## **MEMORANDUM**

**SUBJECT: Public Hearing Report for ZC #08-30B**  
JBG Half Street  
Zoning Commission Design Review Under the Capitol Gateway Overlay

## 2. Variance from Half Street step back requirement (§ 1607.2)

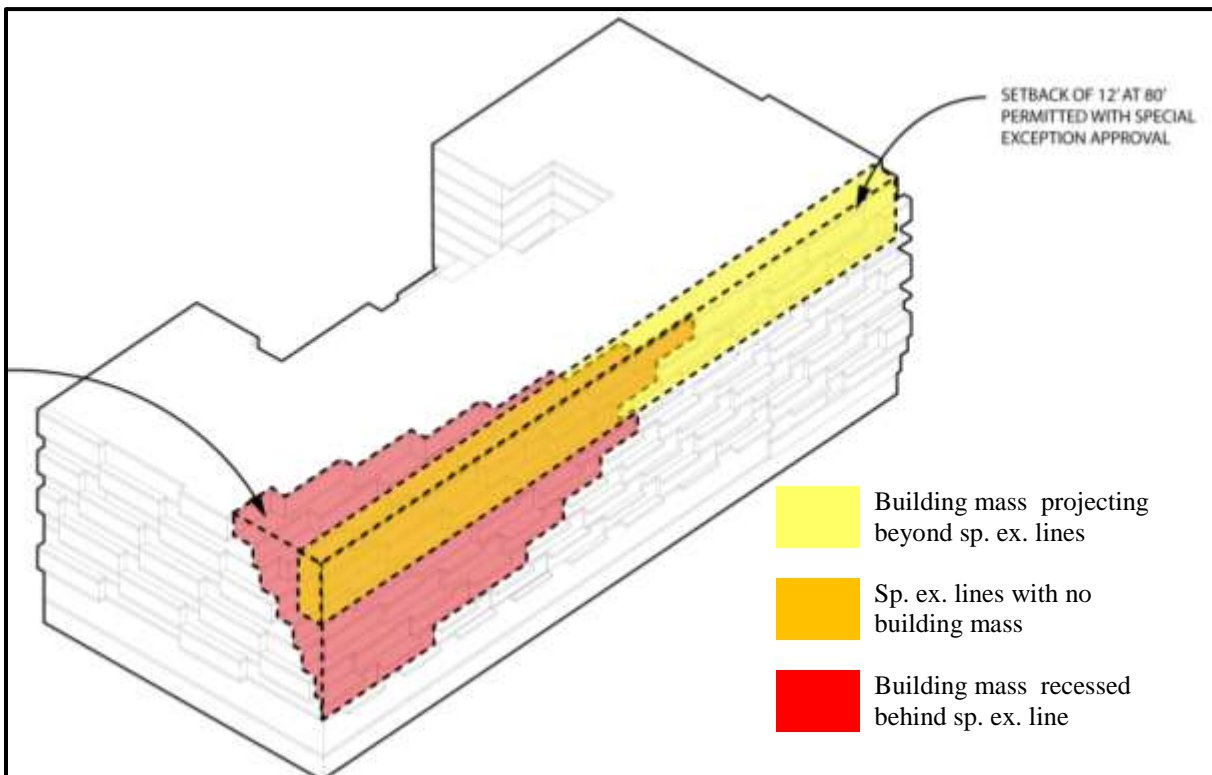
Section 1607.2 requires a 20 foot stepback at 65 feet in height, and permits special exception relief to reduce the stepback to 12 feet at 80 feet in height. The approved application received variance relief to exceed the special exception stepback in certain locations. The current design proposes a building form that recedes away from the south-facing observer on Half Street, using a multitude of cuboid shapes that when coalesced form a sloping surface. At its most prominent, the surface projects forward of the stepback line. Where the building surface is most recessed, at the southern end of the structure, it is well behind the stepback line. The applicant provided OP with the following graphic, which attempts to illustrate the relationship of the building mass to the special exception stepback lines.

OP has no objection to the requested relief. The subject site is unique in that it occupies a prominent location outside of and visible from the interior of the baseball stadium. While not all buildings should be sculptural in form, this location is appropriate for a strong architectural expression. The intent of the regulation – to allow adequate light and air on Half Street and create a pedestrian-scaled environment – would not be impaired. The proposed building form would allow extra light into Half Street by opening up the southern exposure of the street. And while the building would recede from the street, it still would still provide appropriate enclosure with a streetwall up to almost 40 feet at the corner of N and Half.
